Access Compliance Report

Public Rights-of-Way

(Curb Ramps)

Intersection ID: 16828	Main Street: BUCKNELL_AV	Cross Street: SELWYN_AV	Location: NW
ADA ID: 6061303950BF	Ramp Type: Perp	Initial Pass/Fail: Fail	Overall Compliance: No
Severity Score: 1.25			
Codes/Mitigation Info/Possible Solution		Field Measurements/Component Compliance

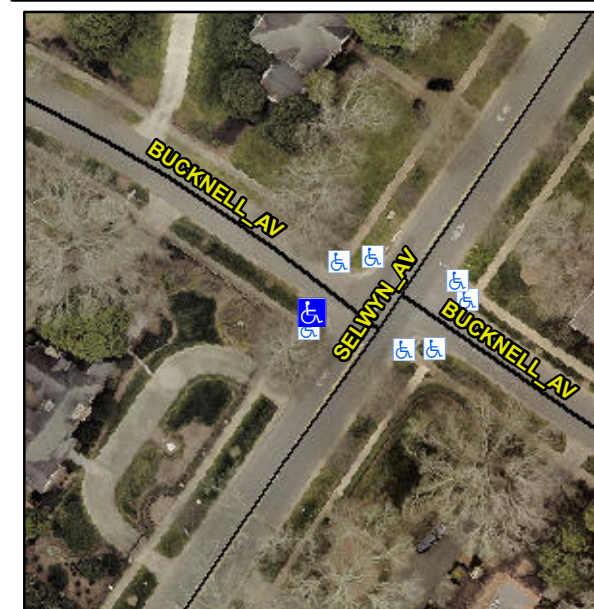
R304.5.3

Compliance	Description	Data	Compliance	Description	Data
N/A	Ramp Length (in)	98.0	Yes	Ramp Slope (%)	5.1
Yes	Ramp Width (in)	58.0	No	Ramp XSlope (%)	3.3
N/A	Flare Type LT	N/A	N/A	Flare Type RT	N/A
N/A	Flare Slope LT (%)	N/A	N/A	Flare Slope RT (%)	N/A
N/A	Flare Traversable LT?	N/A	N/A	Flare Traversable RT?	N/A
N/A	Landing Length (in)	N/A	N/A	DWS Provided?	N/A
N/A	Landing Width (in)	N/A	N/A	DWS Contrast?	N/A
N/A	Landing Slope (%)	N/A	N/A	DWS Length (in)	N/A
N/A	Landing X Slope (%)	N/A	N/A	DWS Full Width?	N/A
N/A	Landing Curb? (Y/N)	N/A	N/A	DWS Offset (in)	N/A
N/A	Shared Landing?	N/A			
N/A	Gutter Ponding?	N/A	N/A	Gutter Slope (%)	N/A
N/A	Gutter Lip Ht (in)	N/A	N/A	Gutter X Slope (%)	N/A
N/A	Painted X Walk1?	No	N/A	Painted X Walk2?	N/A
	X Walk 1 Direction	To NE		X Walk 2 Direction	N/A
N/A	X Walk 1 Width (in)	N/A	N/A	X Walk 2 Width (in)	N/A
	X Walk 1 Slope (%)	1.7		X Walk 2 Slope (%)	N/A
	X Walk 1 X Slope (%)	1.9		X Walk 2 X Slope (%)	N/A

Remove & Replace Entire Ramp.
